This document is a response to the Jamaso (DA-2243-00) Second Technical Submission (5th Overall Review) comments received on June 6th, 2023 by the Office of Development Assistance. Responses are below in **RED**:

Jamaso Subdivision Filing No. 1
 City of Aurora, Colorado
 Master Drainage
 Historic Drainage Plan

Jamaso Subdivision Filing No. 1
City of Aurora, Colorado
Master Drainage
Master Drainage Plan

Proj Name: Jamaso
Location: Aurora, Colorado
Plan Set: PIP
Sheet Name: Public Improvement Plan

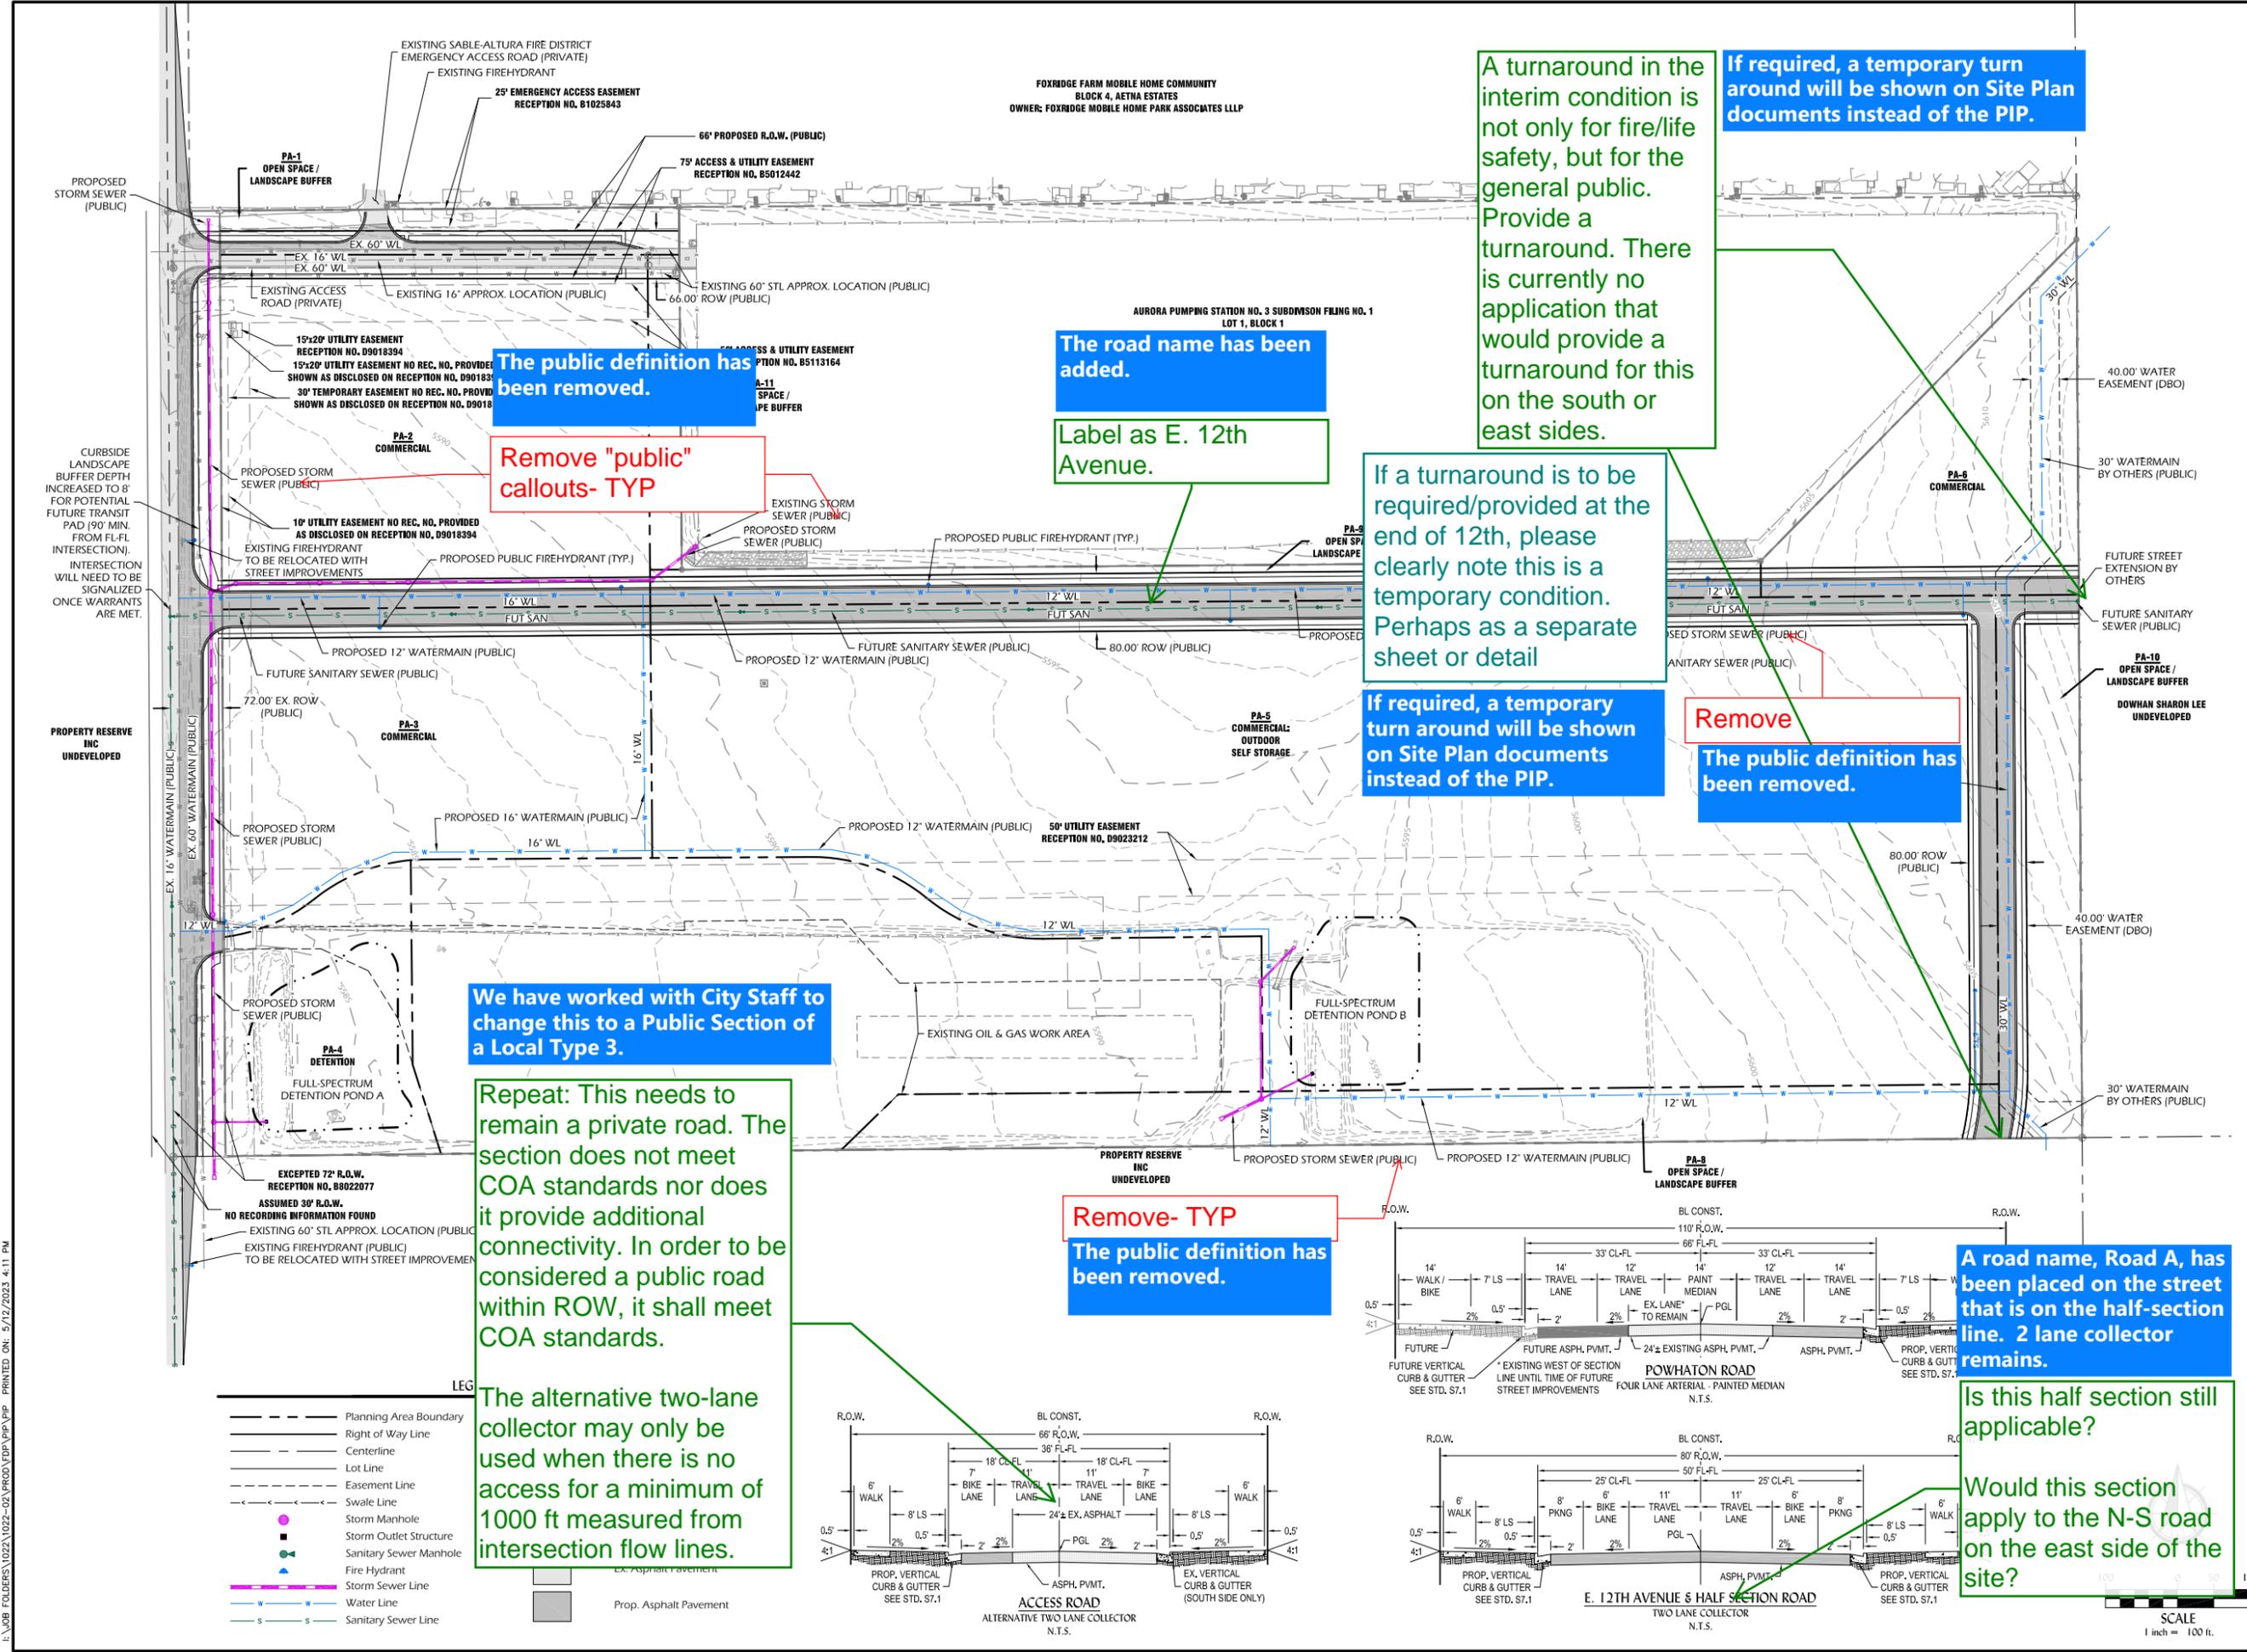
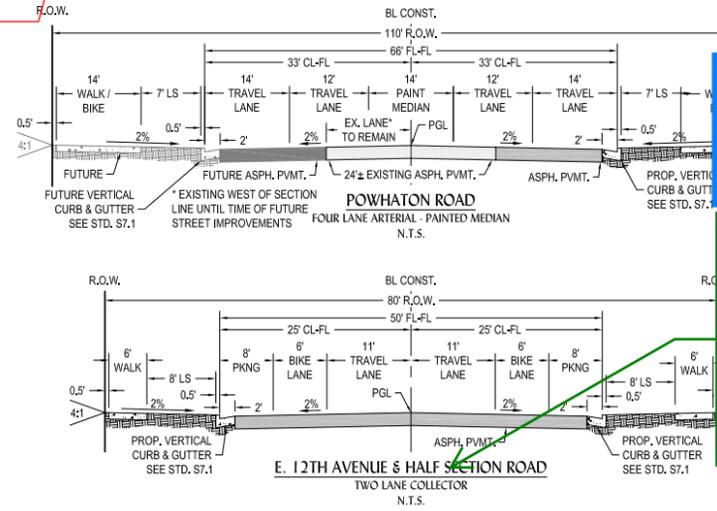
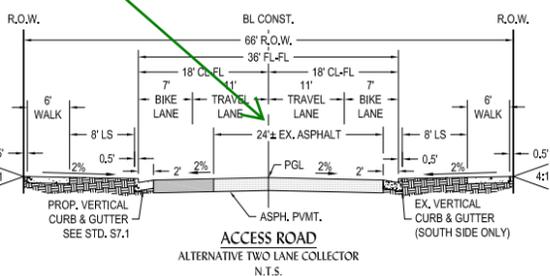
A turnaround in the interim condition is not only for fire/life safety, but for the general public. Provide a turnaround. There is currently no application that would provide a turnaround for this on the south or east sides.

If a turnaround is to be required/provided at the end of 12th, please clearly note this is a temporary condition. Perhaps as a separate sheet or detail

Remove "public" callouts- TYP

Repeat: This needs to remain a private road. The section does not meet COA standards nor does it provide additional connectivity. In order to be considered a public road within ROW, it shall meet COA standards.

If required, a temporary turn around will be shown on Site Plan documents instead of the PIP.

The road name has been added.

If required, a temporary turn around will be shown on Site Plan documents instead of the PIP.

Remove
The public definition has been removed.

We have worked with City Staff to change this to a Public Section of a Local Type 3.

Remove- TYP
The public definition has been removed.

A road name, Road A, has been placed on the street that is on the half-section line. 2 lane collector remains.
